Form No.: 160.00-M1 LS04	1002
	Supersedes: 160.00-M1 (LS04) (702)	
LITERATURE SUPPLEMENT	File with: 160.00-M1	
Subject: Variable Speed Compressor Serial Communications Faults

Figure 1 – ACC Board Wiring Changes

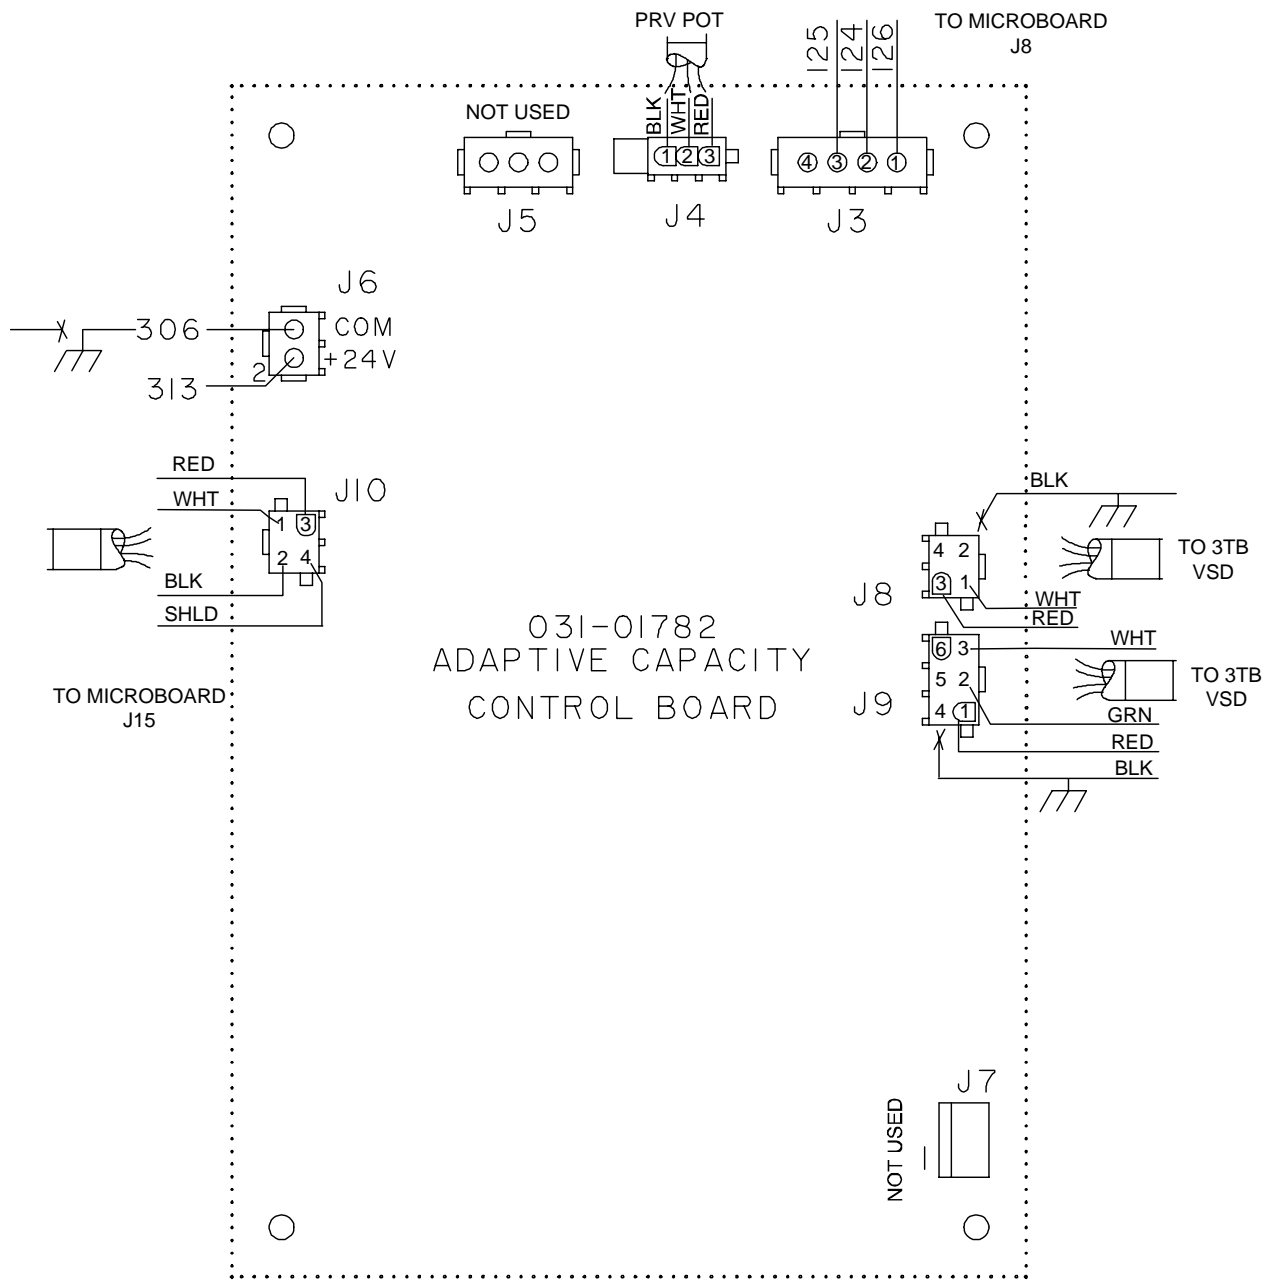
For the following procedures refer to Figure 1.

1. At J6 of the ACC board cut wire 306, 2-½ inches from the ACC board. Tape off the wire end that is not connected to the ACC board. Install a lug on the wire end that is still connected to the ACC board. Drill a hole near the ACC board so this lug can be grounded to the OptiView Control Panel's enclosure. Connect the ground to the enclosure with a self-tapping screw.
2. At J8 of the ACC board remove the black wire insert in pin 2 of J8. Cut off the pin and install a lug on the wire so that it can be connected to the OptiView Control Panel's enclosure. Connect this wire to the enclosure where the shield of J8 is connected.
3. If the Harmonic Filter is not installed, then remove the connector installed in J9. This cable should be tied back so that it is not accidentally reinstalled at a later date.

If the Harmonic Filter is installed, then remove the black wire insert in pin 4 of J9 on the ACC board. Cut off the pin and install a lug on the wire so that it can be connected to the OptiView Panel's enclosure. Connect this wire to the enclosure where the shield of J9 is connected
